RECEIPT DATE: 10/28/15 **ONSITE SEWAGE DISPOSAL SYSTEM** P 557432

PROPERTY ADDRESS: 7374 Guilford Road

I have listed the revisions needed for your BAT plan.

**BAT SITE PLAN**  
7374 GUILFORD ROAD

**SEPTIC SYSTEM ELEVATIONS**

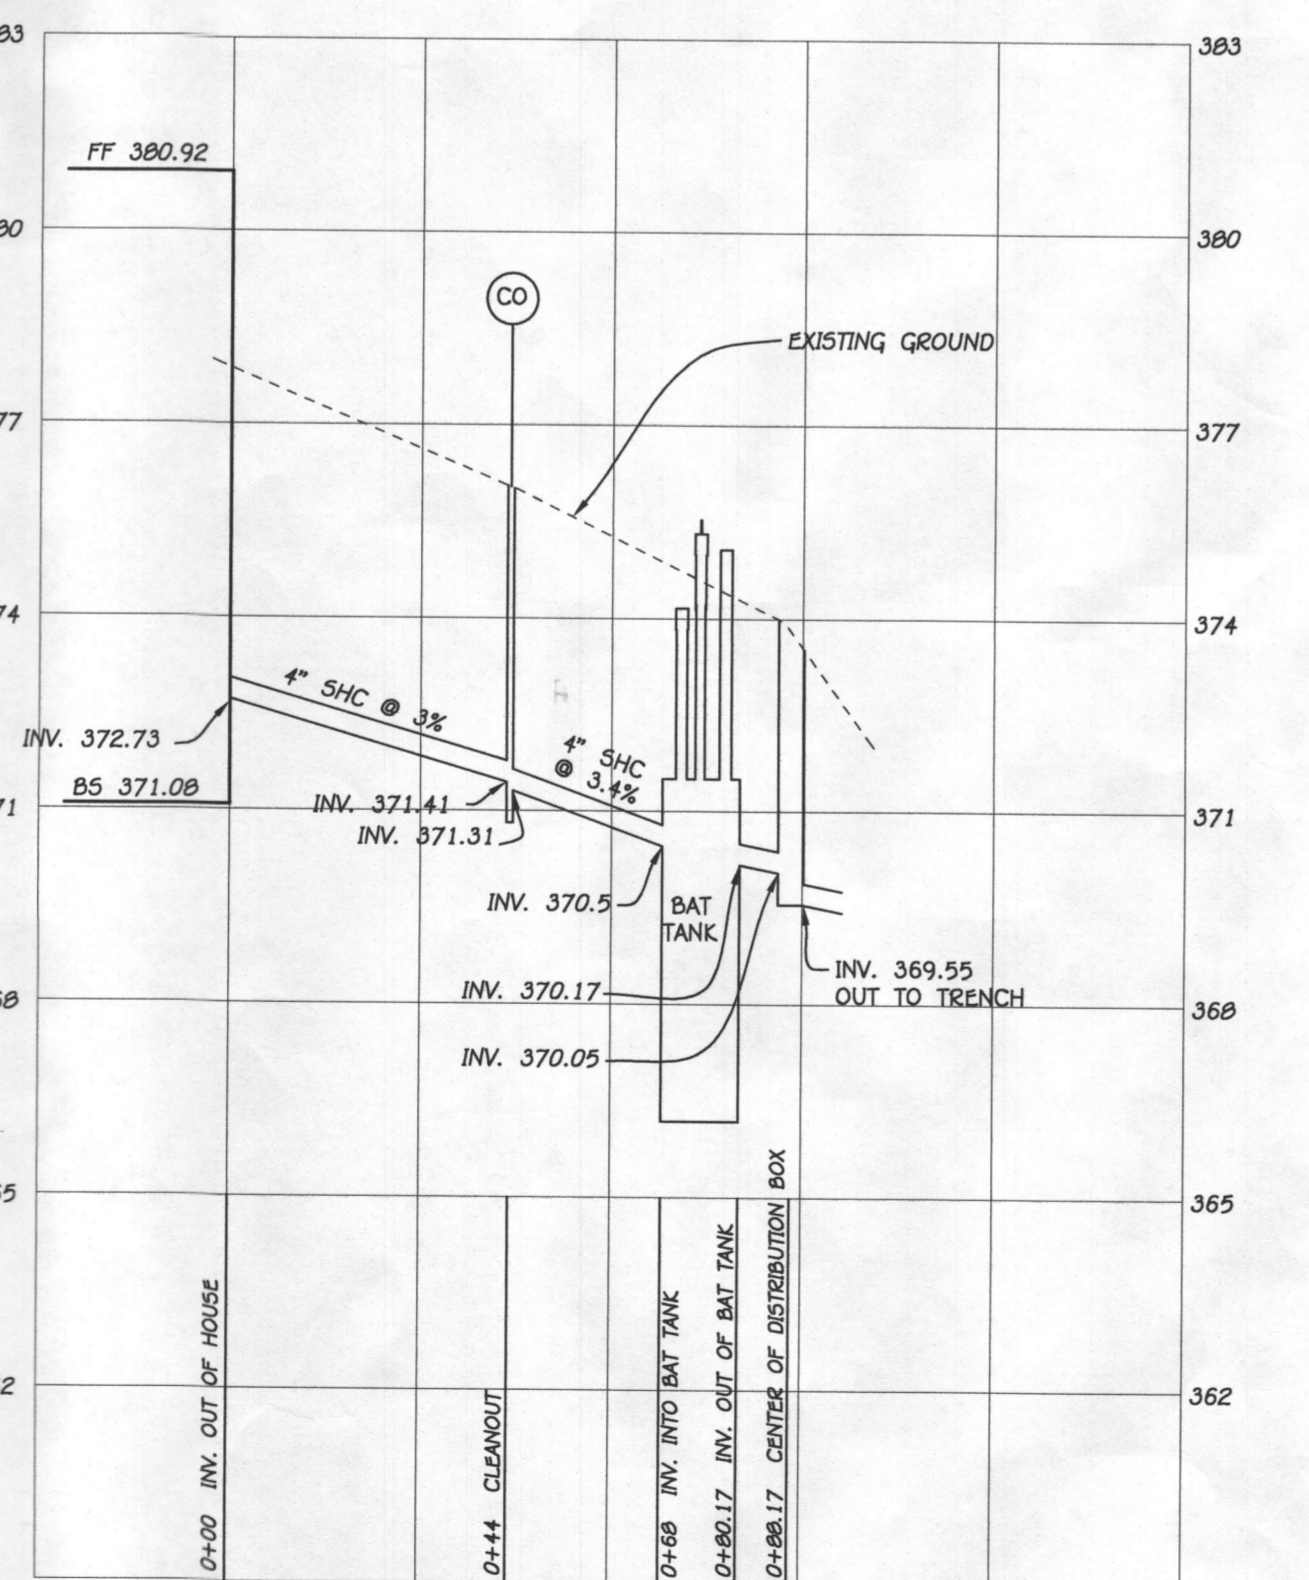
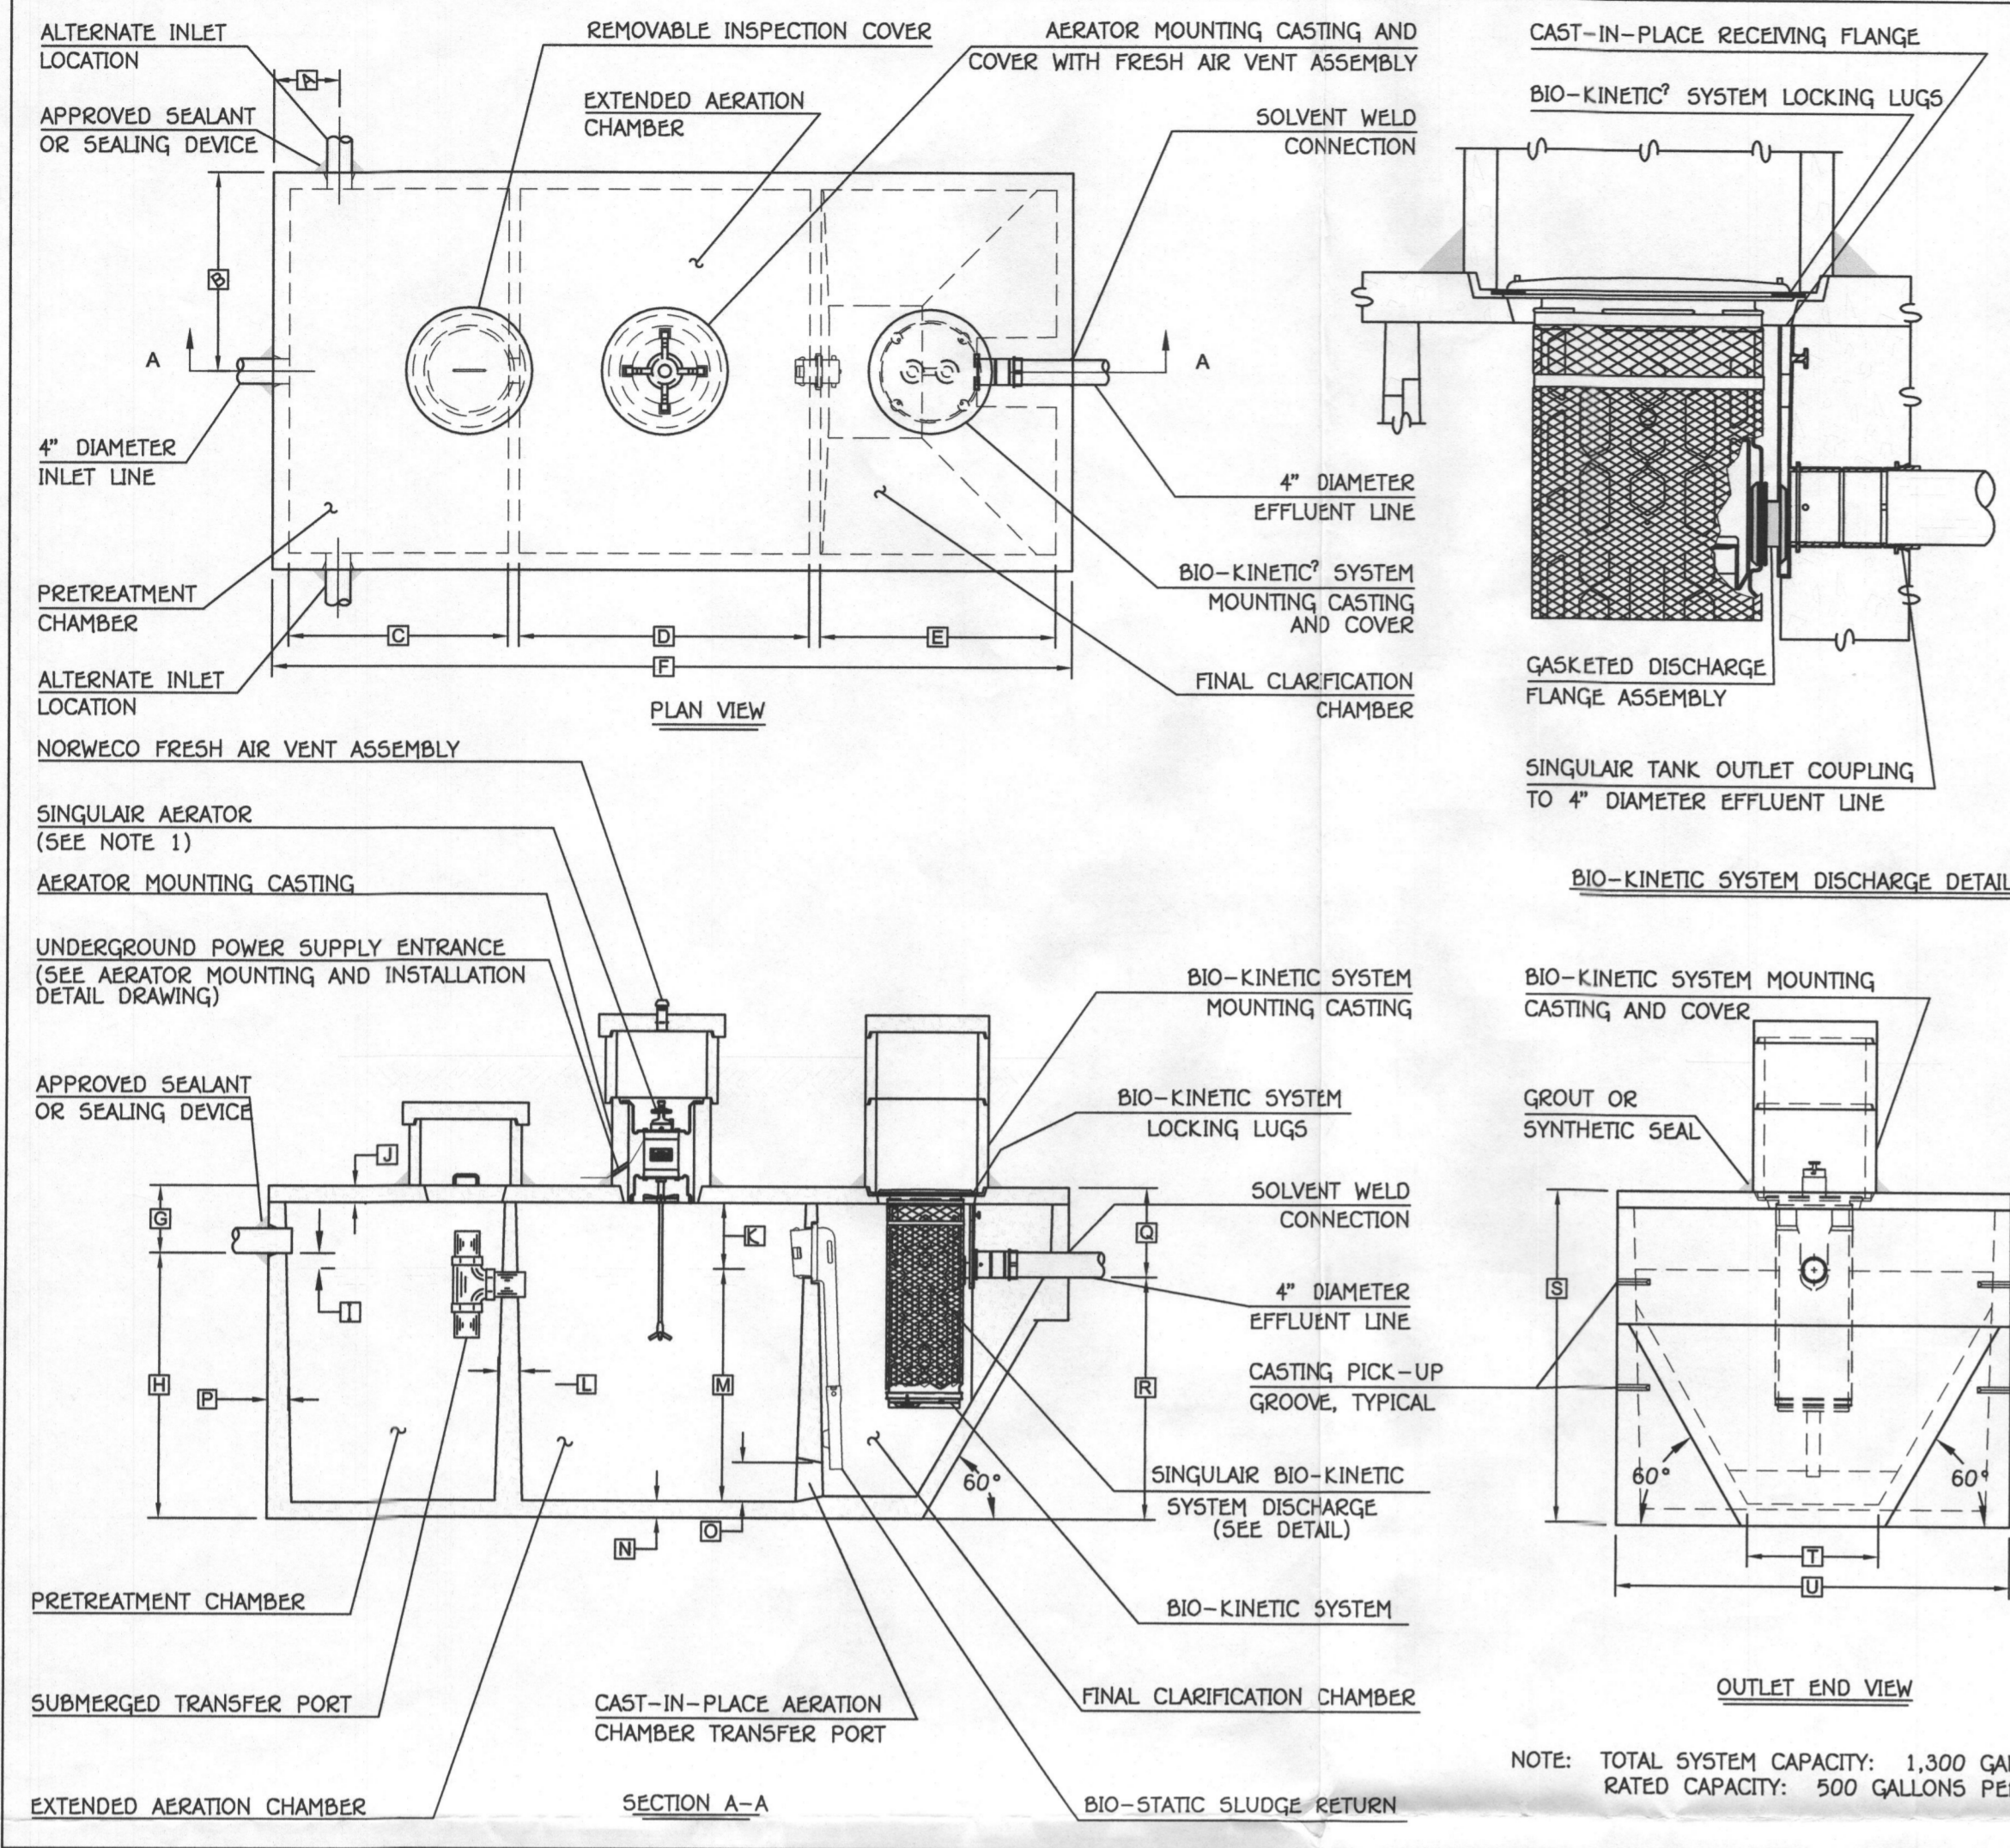
- ❖ We will need to change the number of bedrooms on your building permit to reflect the number of bedrooms shown on your BAT plan.
- ❖ Revise calculations on your BAT plan to reflect proposed number of bedrooms.
- ❖ Remove line 5 from the general notes.
- ❖ Currently your floor plans reflect 5 bedrooms with a possible 6<sup>th</sup> bedroom in the basement I recommend this statement be added to the general notes.

If a building permit is submitted any time in the future, a septic system upgrade will be required to finish the area currently identified as the basement. At that time a septic system upgrade will be required as finishing the basement could possible create a sixth bedroom per Howard County code 3.801(B).
